## **REMARKS**

This is a full and timely response to the outstanding non-final Office Action mailed June 7, 2004. Upon entry of the amendments in this response, claims 20 - 24 remain pending. In particular, Applicant has amended claims 20 – 24, and has canceled claims 1 – 19 with out waiver, disclaimer or prejudice. Applicant has canceled claims 1 - 19 merely to reduce the number of disputed issues and to facilitate early allowance and issuance of other claims in the present application. Applicant reserves the right to pursue the subject matter of these canceled claims in a continuing application, if Applicant so chooses, and does not intend to dedicate the canceled subject matter to the public. Reconsideration and allowance of the application and presently pending claims are respectfully requested.

FIG. 7B

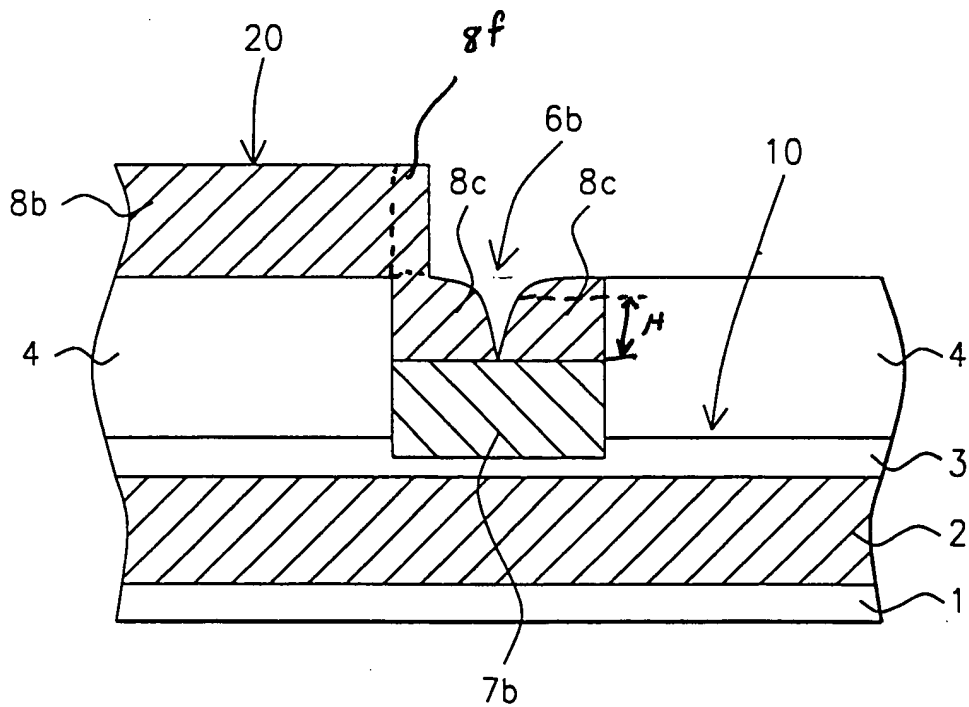
In the attached replacement sheets of drawings, Applicant has added a thickness H of the metal ring component in Fig. 7B to clarify how the thickness continually decreases from each side to a center of said via hole. Also in Fig. 7B, a dash line is added to indicate where a first portion 8e and a second portion 8f are in the metal interconnect component 8b. As shown in Fig. 7B, the first portion 8e of the metal interconnect component 8b is located on a first portion of a smooth top surface of the ILD layer 4 and the second portion 8f of the metal interconnect component 8b on the via hole 6b contacts a top surface of the metal ring component 8c. Symbol H is added to show the thickness of the metal ring component which continually decreases from each side to a center of the via hole 6b. A boundary 8d as shown in Fig. 6 is emphasized to show that it is located between the sides of the via hole 6b. Furthermore, according to the process in the original specification, the boundary 8d is formed by photolithography and etching process.

The Office Action indicates that Claims 20-24 stand rejected under 35 U.S.C. 112, second paragraph. Specifically, the Office Action alleges that it is unclear as to how the metal ring structure continually decrease in thickness as it approaches the center of the via hole. Applicant respectfully traverses the rejection.

In this regard, Applicant respectfully asserts that the original disclosure fully and accurately describes the aforementioned features. However, as set forth above, Applicants have made minor amendments to the drawings and respectfully assert that the rejection has been rendered moot. Specifically, Fig. 7B has been amended to point out a thickness H of the metal ring component. In Fig. 7B, H has a maximum at the sidewall of the via hole 6b and has a minimum at the center of the via hole 6b. Thus, Applicant respectfully assert that it is clear how the metal ring component 8c continually decreases in thickness from each side to a center of the via hole 6b.
